Process and Product Change Notification

MV5074C/MV5074C_7144/MV5075C/MV5077C/MV5374C/MV5377C/MV5474C/MV5477C/MV5774C/MV5777C

Original drawing (leadframe 2005/ casting model 2230)	Original drawing (leadframe 2005/ casting model 2240)	Changed drawing (leadframe 2004-10/ casting model 200)

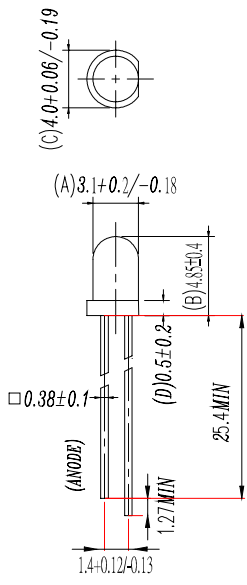
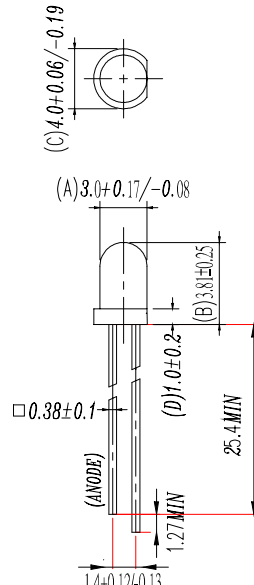
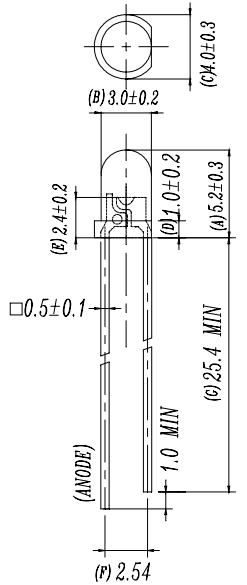
The leadframe 2005 instead by 2004-10 and the casting model 2230/2240 instead by 200,Refere follow drawing.

This only change the dimension,And will not effected the reliability.
